**MUNICIPAL PLANNING COMMISSION AGENDA
SUMMER VILLAGE OF BIRCHCLIFF
SUMMER VILLAGES ADMINISTRATION OFFICE
MARCH 1, 2021 @ 9:00 A.M.**

71 Birchcliff Road (Lot 2, Block 4, Plan 4486AX)

Development Permit Application

363 Birchcliff Road (Lot 12PT, Block -, Plan 6333KS)

SKETCH PLAN

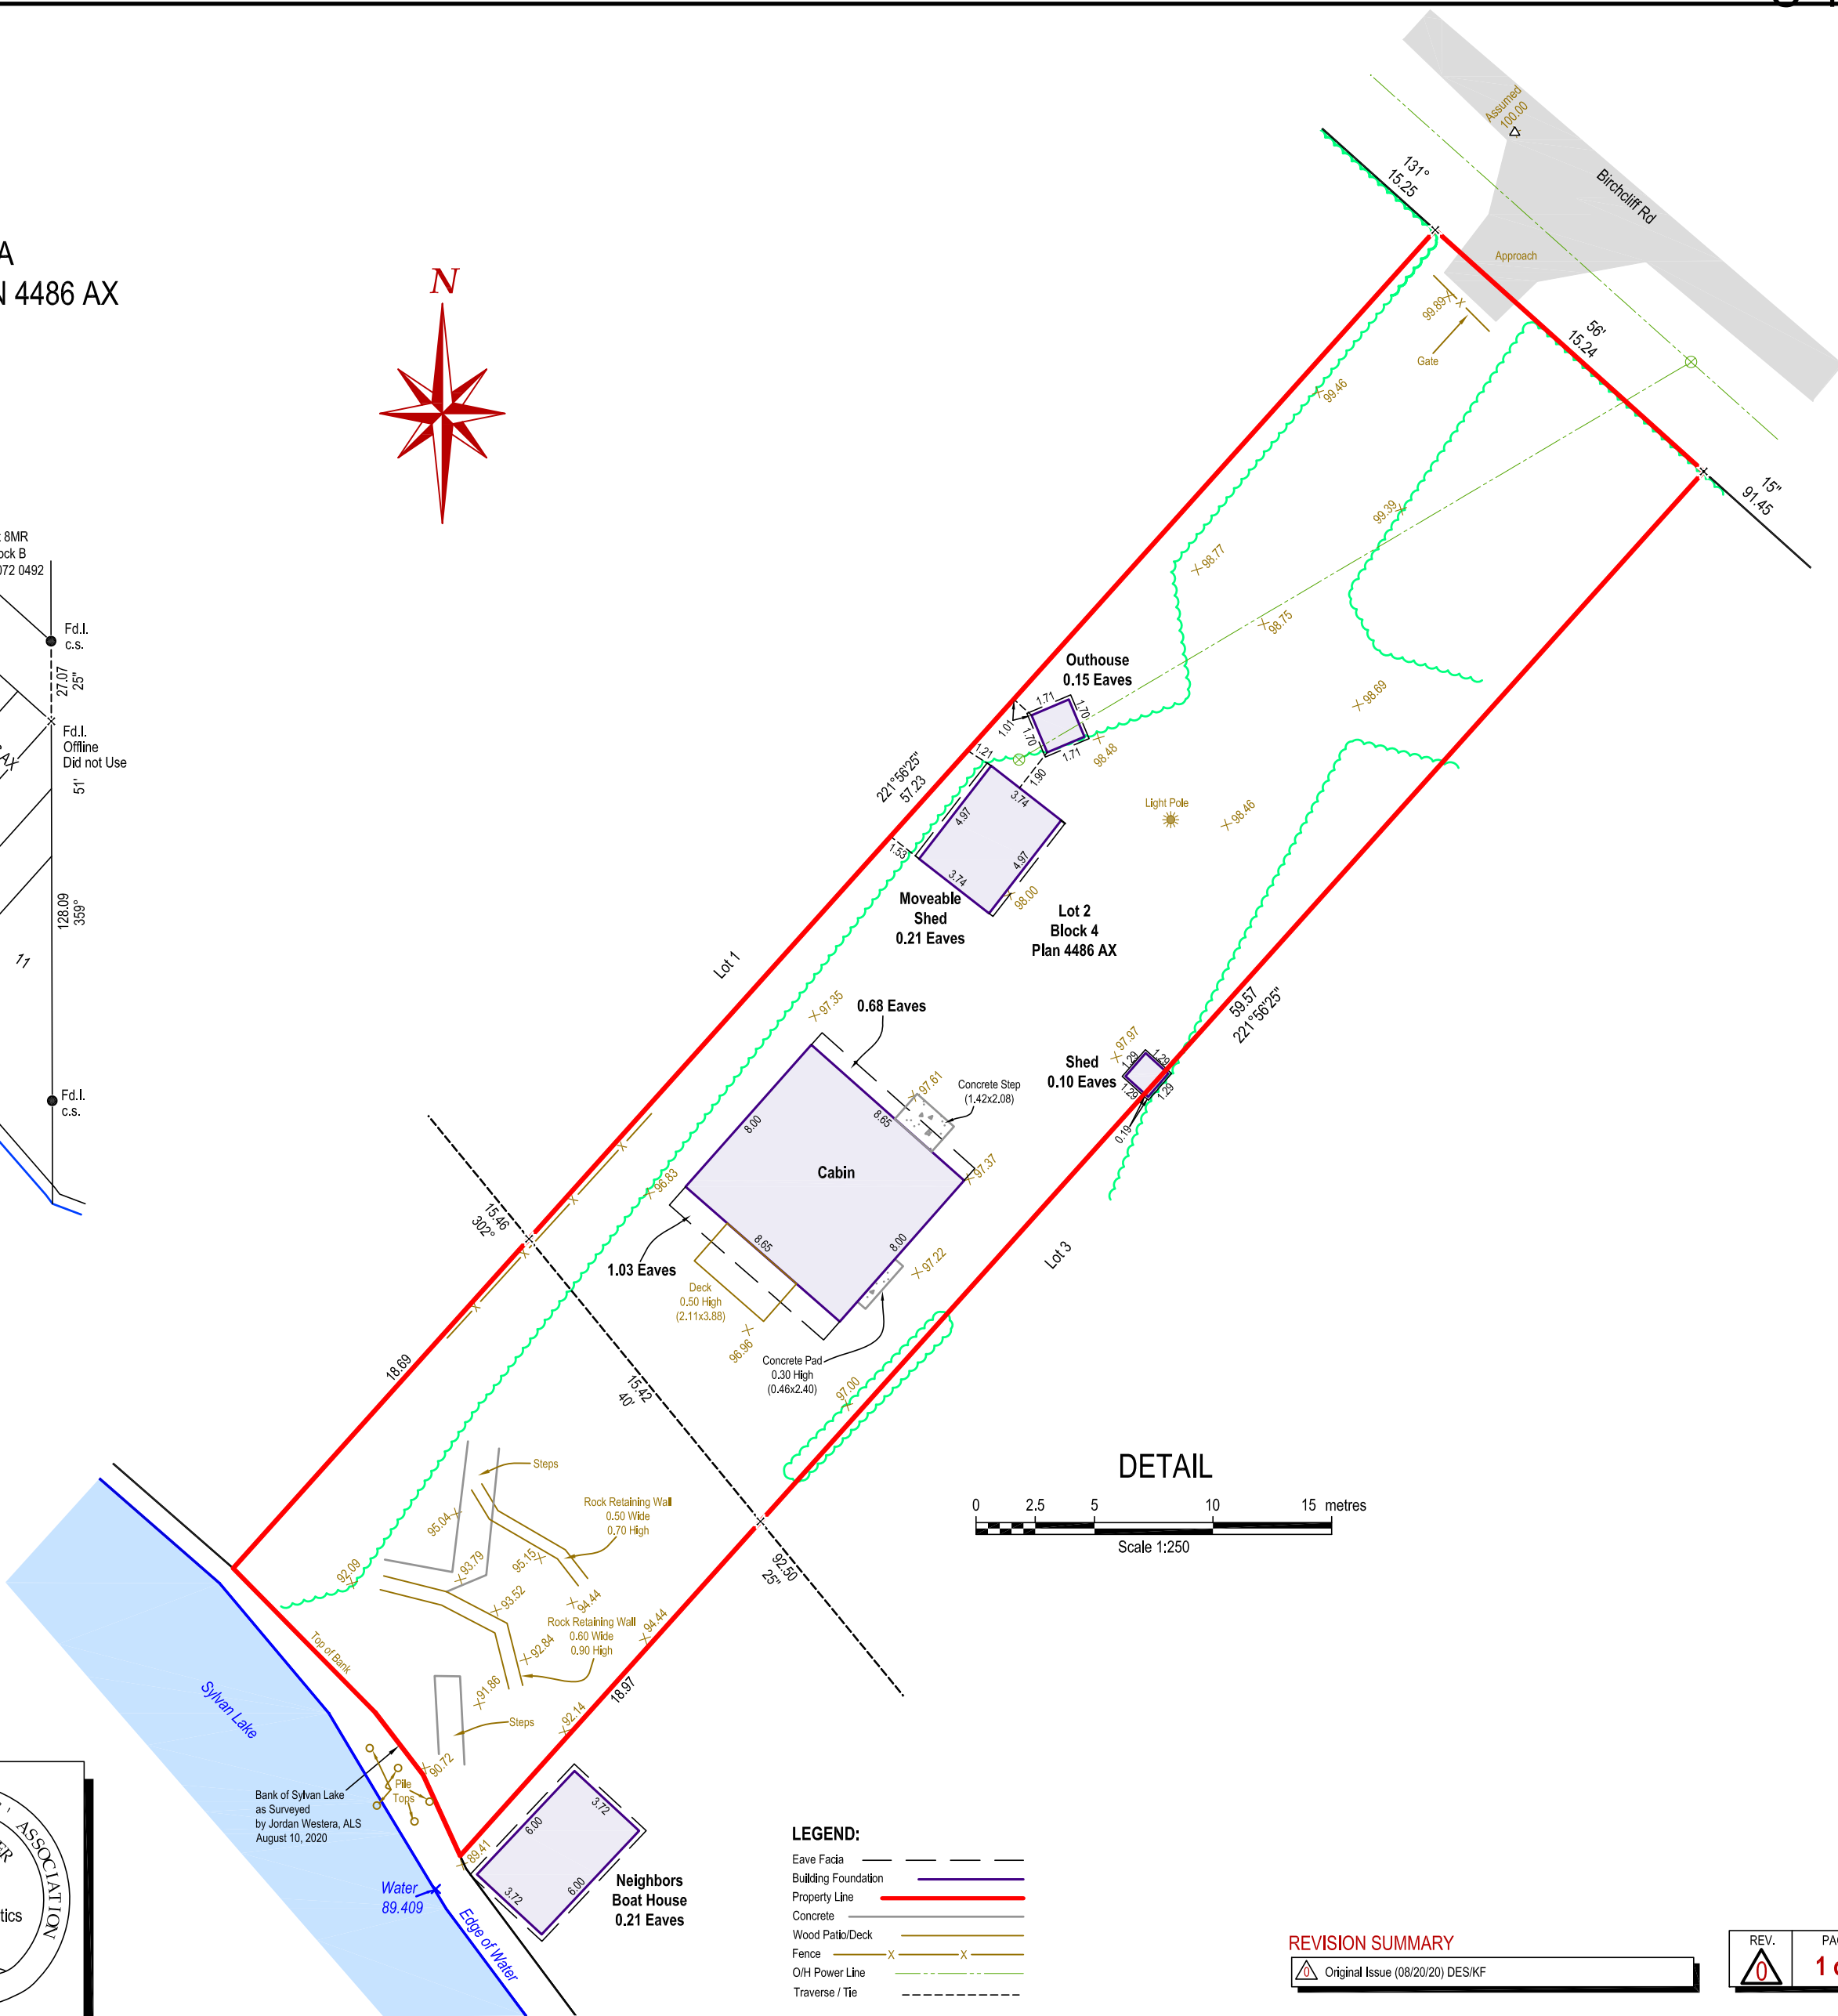
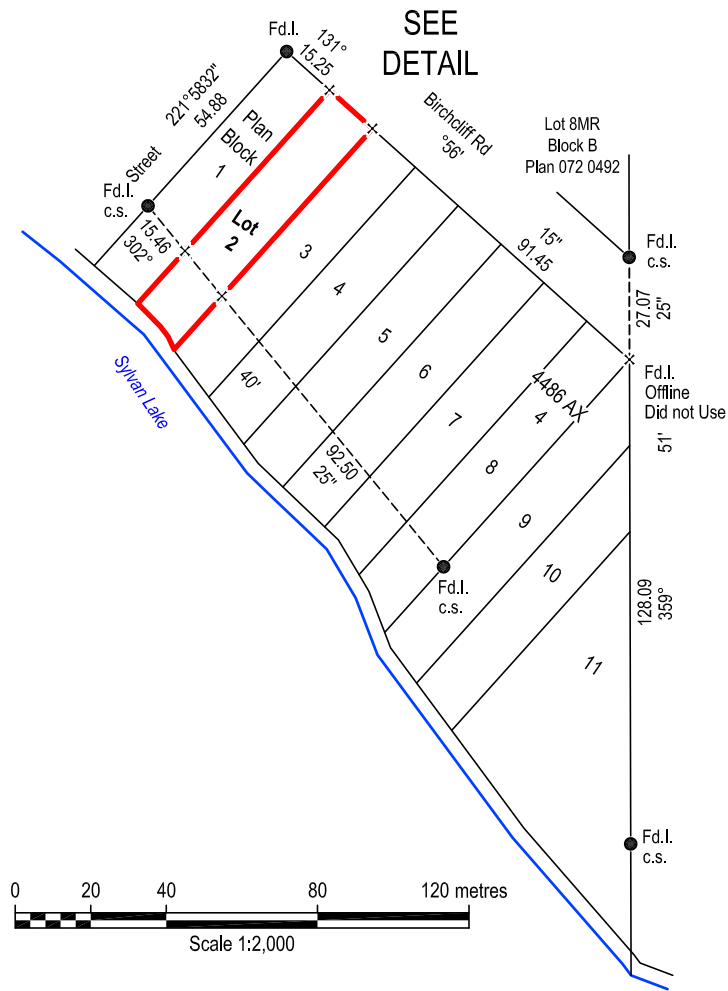
- Mechanized Excavation, Stripping and Grading is listed as a discretionary use; therefore, the decision must come from the Municipal Planning Commission.
- Land located below the top of bank/top of escarpment should be in a natural state, a variance is required.

After reviewing all relevant planning and other statutory documents, it is the recommendation of administration to deny the application. The bank stabilization work may seem necessary, but the proposed development should have proposed landscaping that includes heavily native vegetated areas with no man made beaches and include a no mow zone adjacent to the lake.

- At minimum, the same number of trees removed from the escarpment to be replaced.
- Minimum 1m no mow zone required adjacent to lake, including native grassy areas.
- Proposed grass areas between retaining walls to be left natural and be heavily vegetated with native plantings.
- No beach to be created.
- Land below the escarpment to be left natural with no seating areas, firepits, or decks.
- Future dwelling plans are to comply with the geotechnical report recommendations to ensure that the bank is protected, and the development is safe.

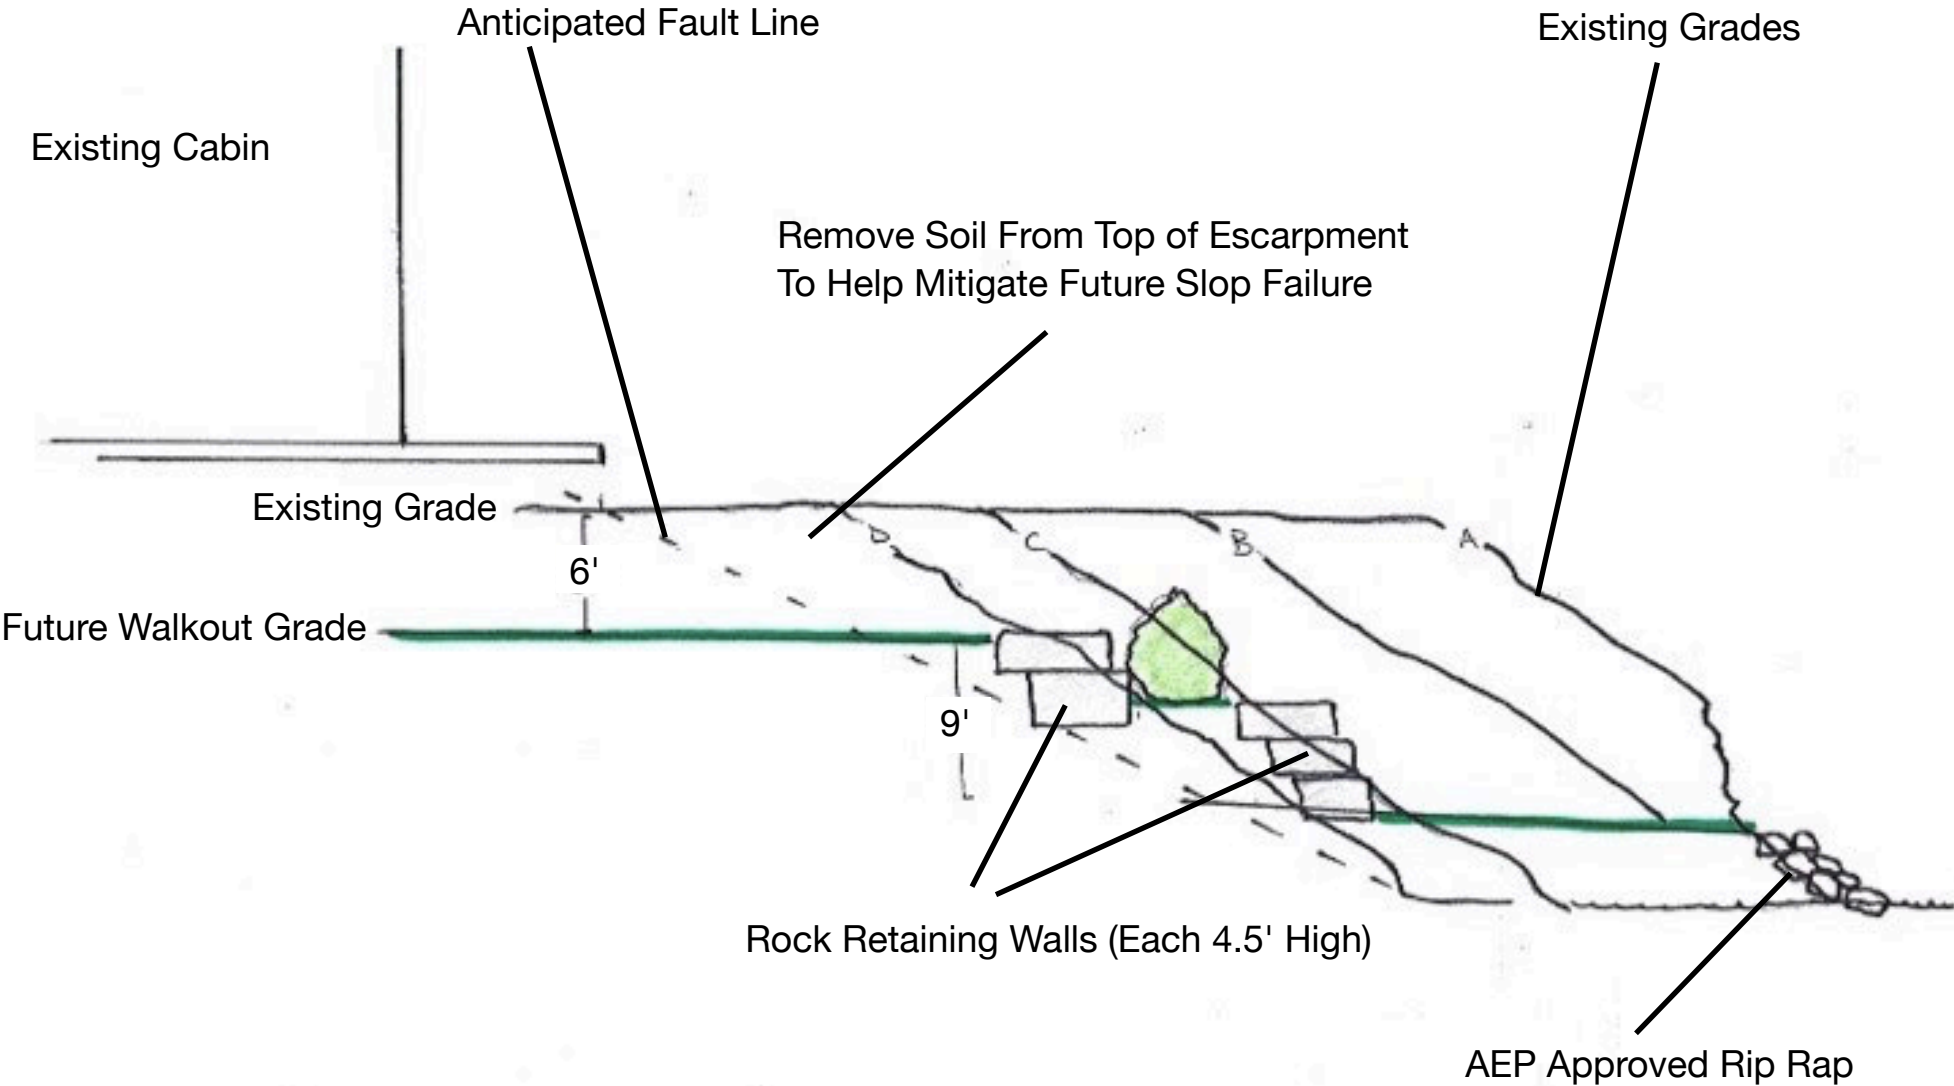
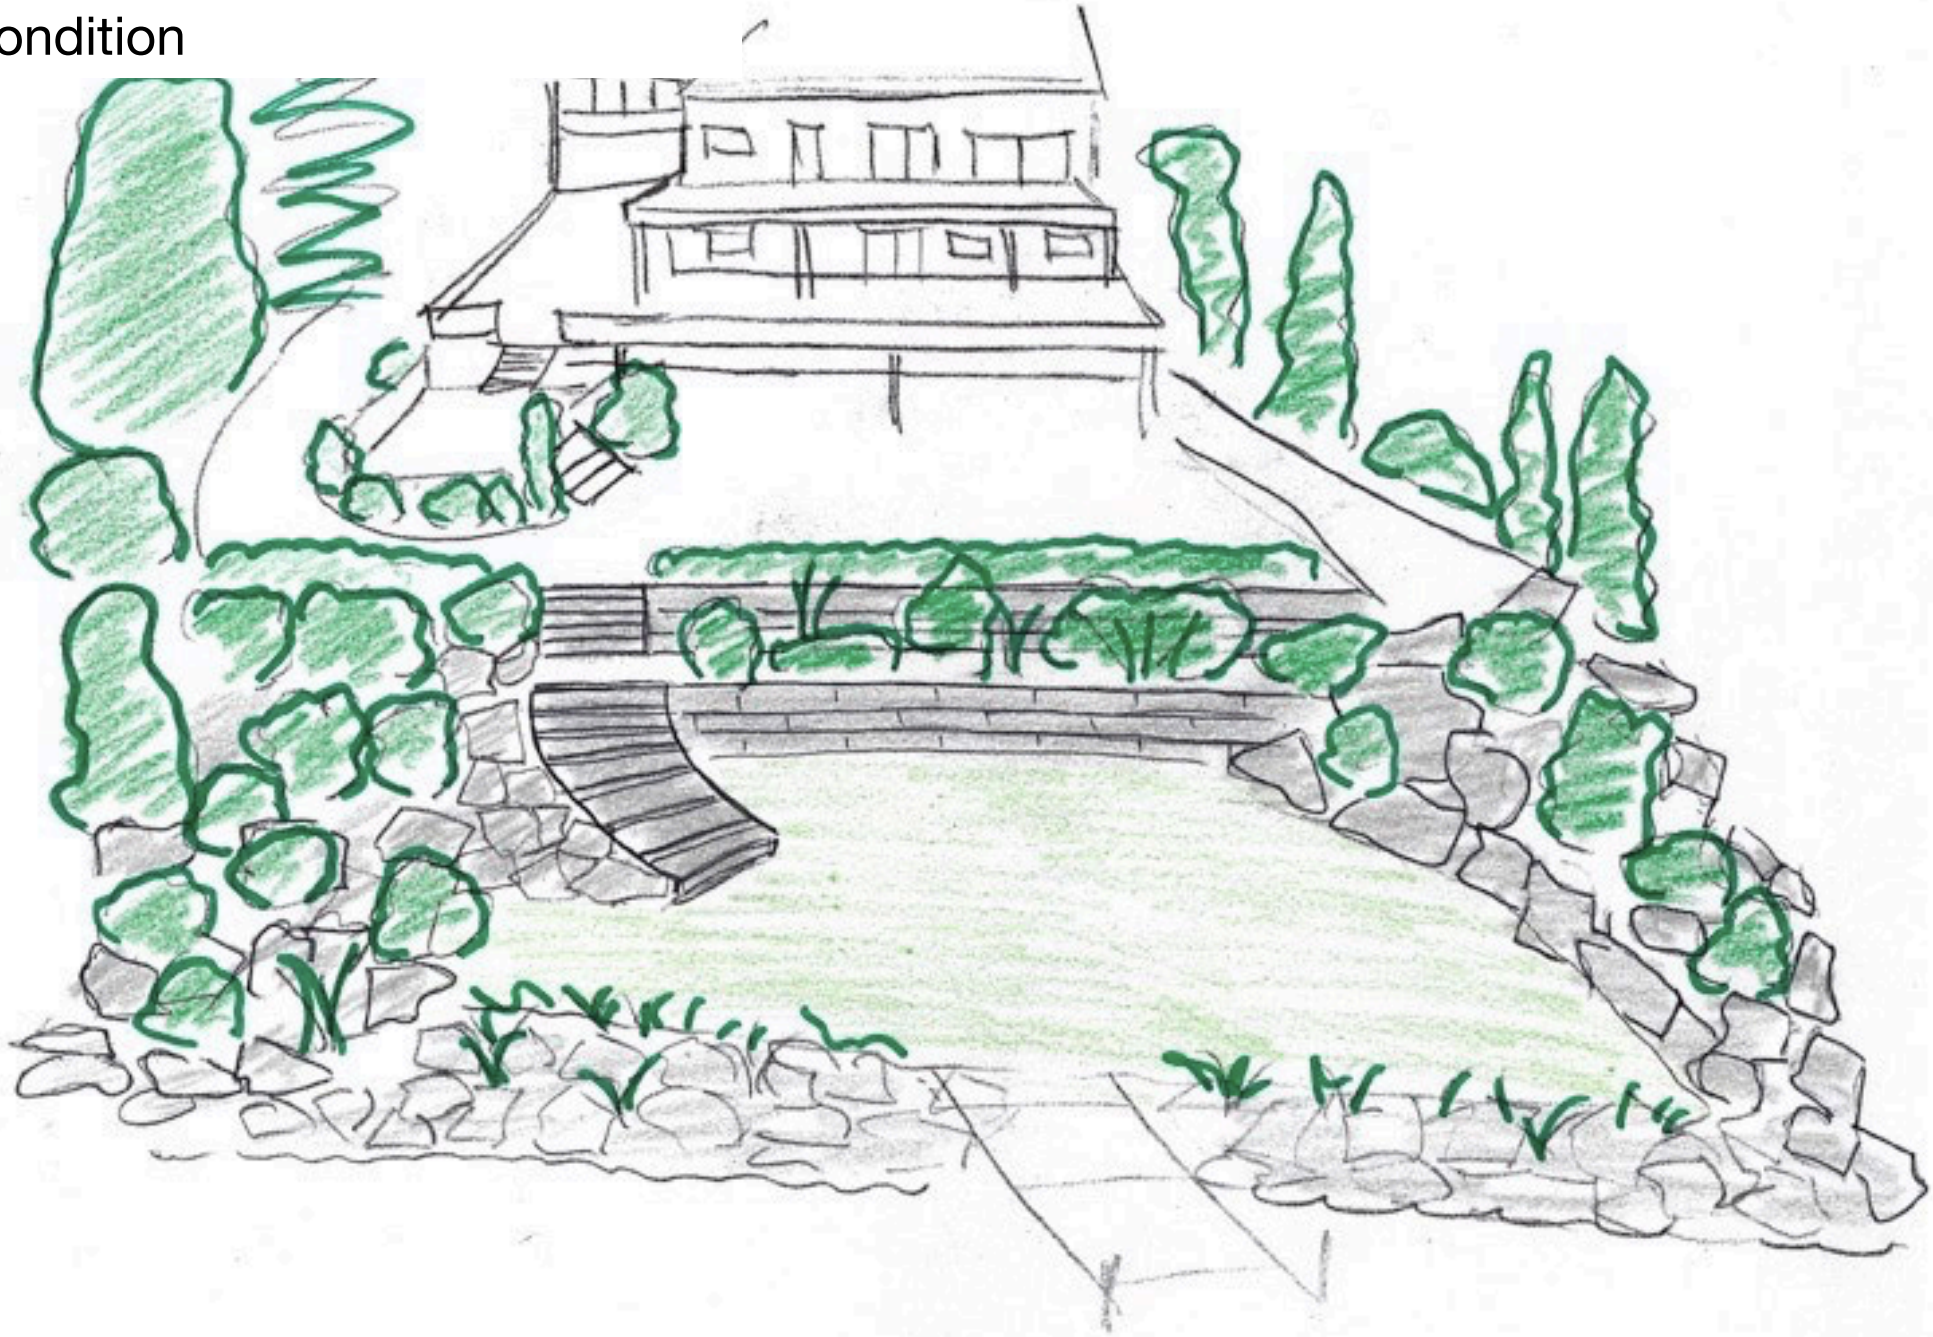
8 Mature trees to be removed

Deck and stairs to be removed

Failing structure to be removed

- Completions Deposit of \$5,000.00
- Vegetation to be planted according to the landscaping plan, including the minimum replacement of 8 trees, with a minimum 1m no mow zone adjacent to the lake.
